**METROPOLITAN GOVERNMENT OF NASHVILLE AND DAVIDSON COUNTY**

**STAFF RECOMMENDATION**  
**919 McFerrin Avenue**  
**February 19, 2014**

**Application:** New construction—infill  
**District:** Greenwood Neighborhood Conservation Zoning Overlay  
**Council District:** 06  
**Map and Parcel Number:** 08204037800  
**Applicant:** William Gant, owner  
**Project Lead:** Melissa Baldock, melissa.baldock@nashville.gov

<p><b>Description of Project:</b> Application is to construct infill on a vacant parcel.</p> <p><b>Recommendation Summary:</b> Staff recommends disapproval of the infill, finding that its tall porch wall height, lack of a defined foundation, flat roof form, stucco cladding, and proportion and rhythm of openings do not meet Section II.B.1. of the <i>Greenwood Neighborhood Conservation Zoning Overlay: Handbook and Design Guidelines</i>.</p> <p>Staff finds that the basic massing, scale and layout of the house is appropriate and a simple alteration of roof form, materials and windows are all that are needed to meet the design guidelines. Although these alterations are simple to accomplish, they do radically change the look of the building which is why Staff is not recommendi

919 MCFERRIN AVENUE

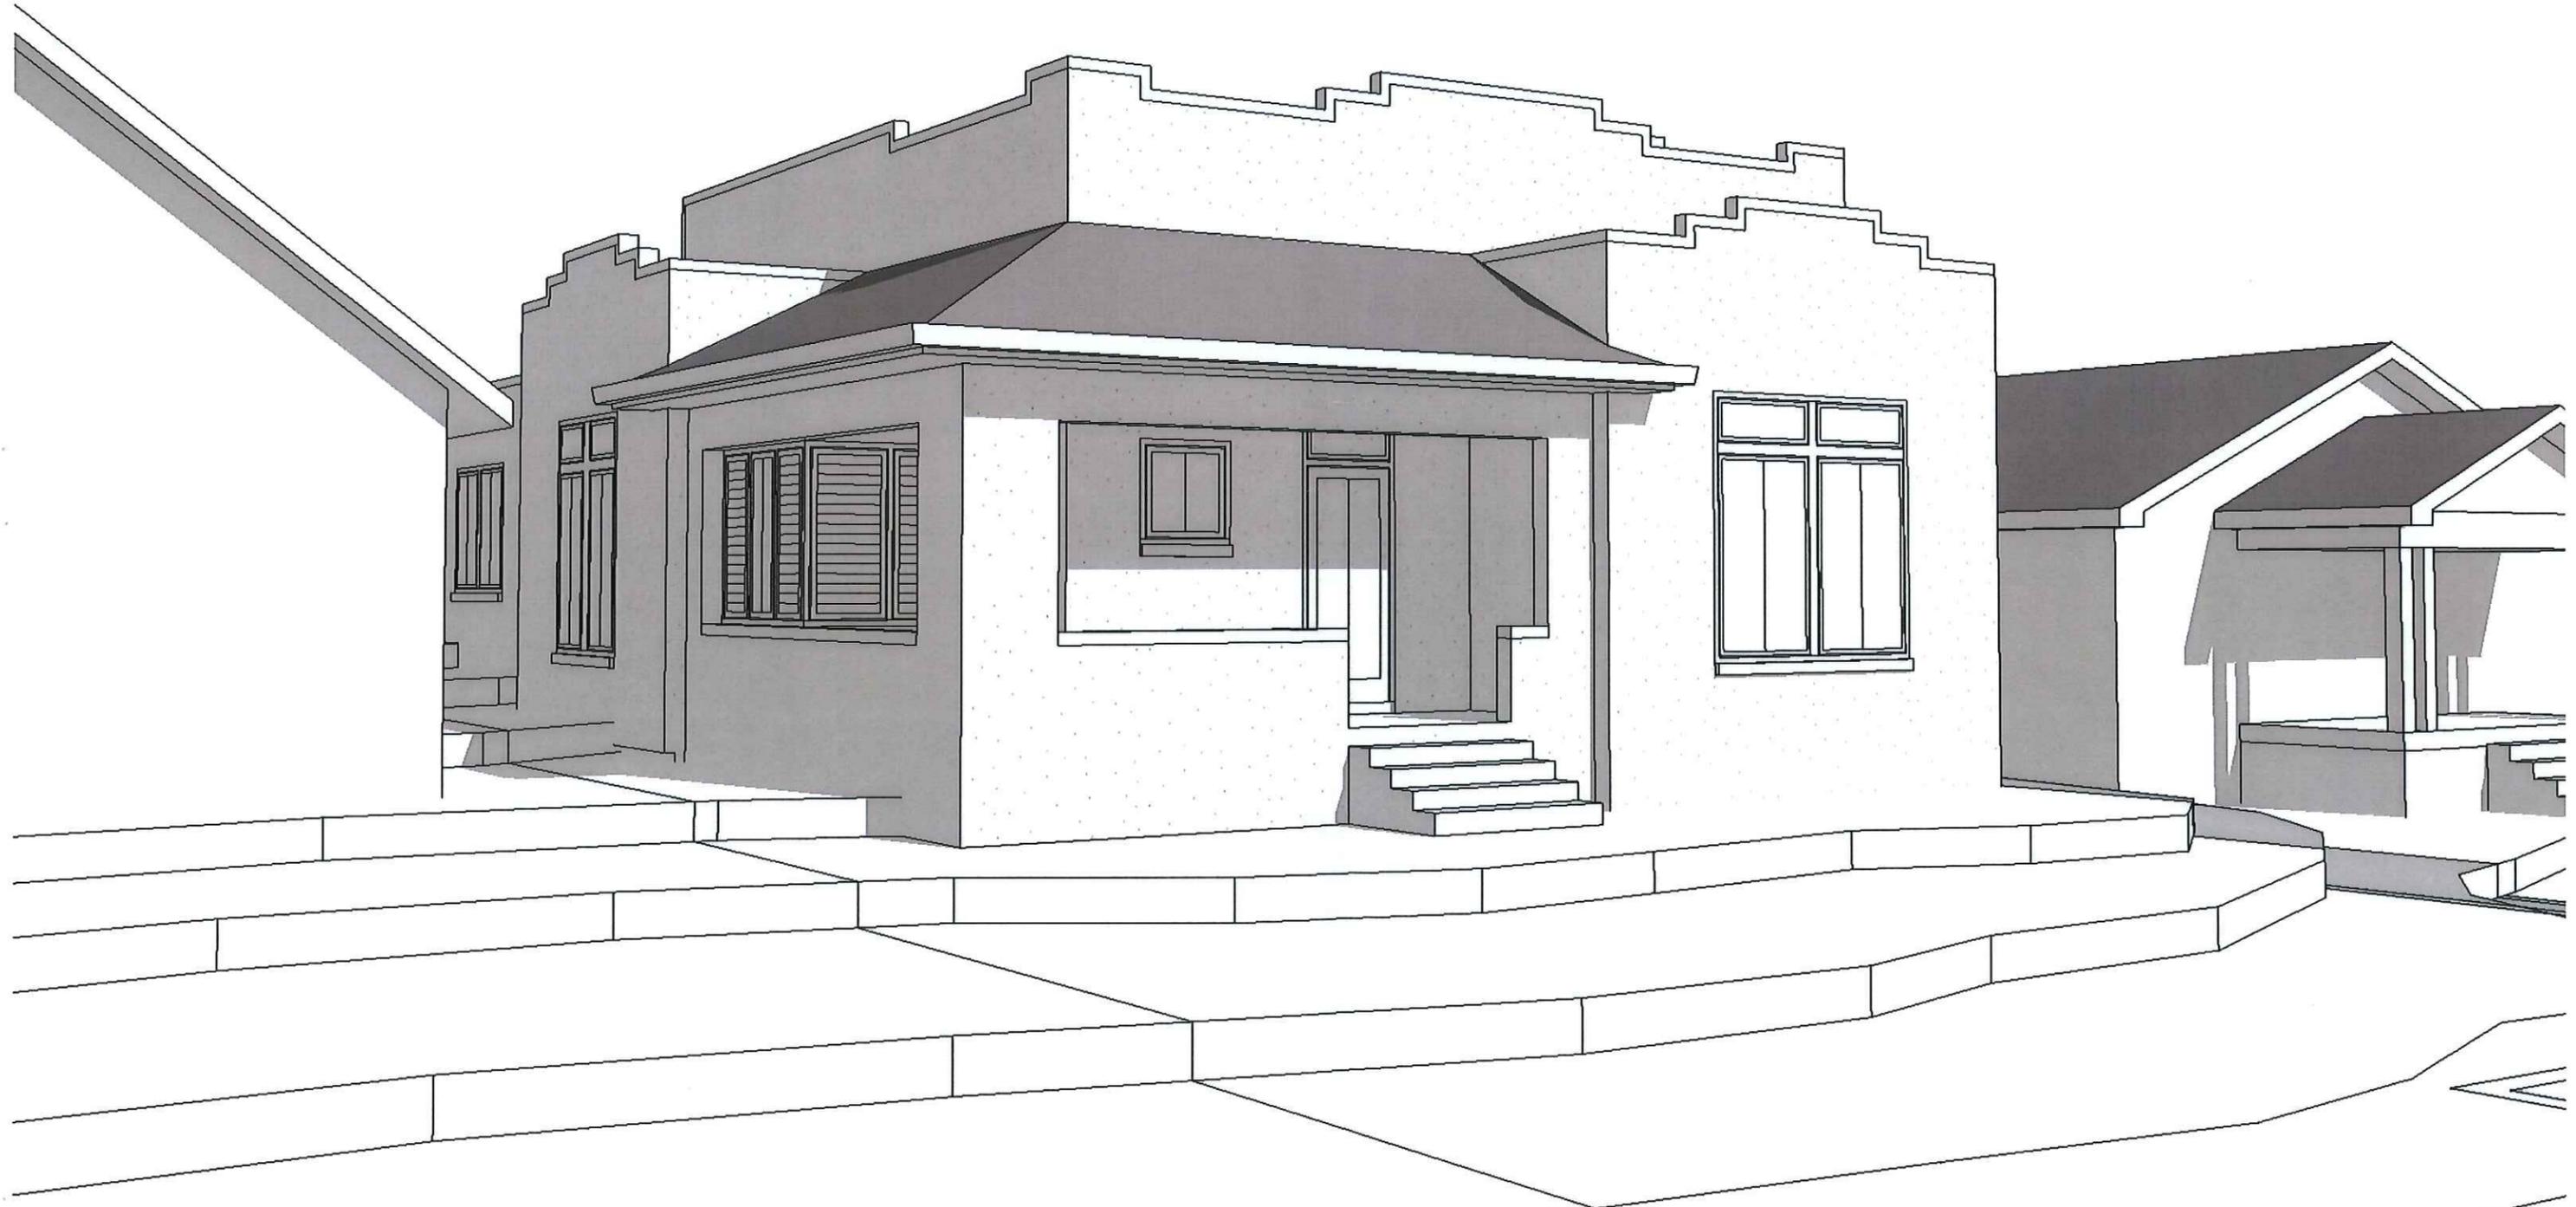
The house lacks a foundation line, so there is no foundation height to measure. This is not typical of historic houses in the Greenwood neighborhood, which have a change in material from the foundation to the cladding above. The five foot (5') tall porch wall is also atypical for the Greenwood area. This type of tall wall creates a somewhat "enclosed" porch design which is more typical of architectural styles that are not found in this neighborhood. More characteristic here are porches with open railings or no railings and narrower posts, creating a more open feel.

While the overall height and width of the proposed infill matches the historic context, the lack of a defined foundation line and the tall front porch wall do not match the historic context. Staff therefore finds that the infill does not meet sections II.B.1.a. and b. of the *Greenwood Neighborhood Conservation Zoning Overlay: Handbook and Design Guidelines*.

Materials: The primary material for the infill is stucco. Staff did not identify any historic structure in the Greenwood conservation overlay with stucco as its primary material. The vast majority of the historic structures in the neighborhood have brick or lap siding as their primary material. The porch roof and side awning will be composite shingle, which is appropriate. The parapet will have masonry coping. The windows and front door will be wood. Because the stucco facade is not appropriate for the Greenwood neighborhood, staff finds that the project's materials do not meet Section II.B.1.d. of the *Greenwood Neighborhood Conservation Zoning Overlay: Handbook and Design Guidelines*.

Roof form: The applicant is proposing a flat roof form for the majority of the house, with a hipped porch roof and a hipped awning on the right/south façade. Staff did not identify any flat roof residential structures in the Greenwood conservation zoning overlay. Therefore staff finds that the roof form is incompatible with the surrounding historic roof forms which are generally gabled or hipped. Staff finds that the infill's flat roof does not meet Section II.B.1.e. of the *Greenwood Neighborhood Conservation Zoning Overlay: Handbook and Design Guidelines*.

Proportion and Rhythm of Openings: The primary windows are generally twice as tall as they are wide, thereby meeting the historic proportion of window openings. One exception is a three foot by three foot (3' X 3') window opening on the front façade, to the left of the door. A window like this on the front façade should be at least twice as tall as it is wide. The front façade has a window opening that is filled with shutters and wraps around the corner to the north/left façade. It is not clear if the shutters are fixed or if they are operable. In either case, staff finds that the shutters do not meet the design guidelines. Staff requires more information on the shutters before determining whether or not they meet the design guidelines. Staff finds the project's proportion and rhythm of openings do not meet Section II.B.1.g. of the *Greenwood Neighborhood Conservation Zoning Overlay: Handbook and Design Guidelines*.

Staff recommends disapproval of the infill, finding that its tall porch wall height, lack of a defined foundation, flat roof form, stucco cladding, and proportion and rhythm of openings do not meet Section II.B.1. of the *Greenwood Neighborhood Conservation Zoning Overlay: Handbook and Design Guidelines*.

Staff finds that the basic massing, scale and layout of the house is appropriate and a simple alteration of roof form, materials and windows are all that are needed to meet the design guidelines. Although these alterations are simple to accomplish, they do radically change the look of the building which is why Staff is not recommending approval with conditions.
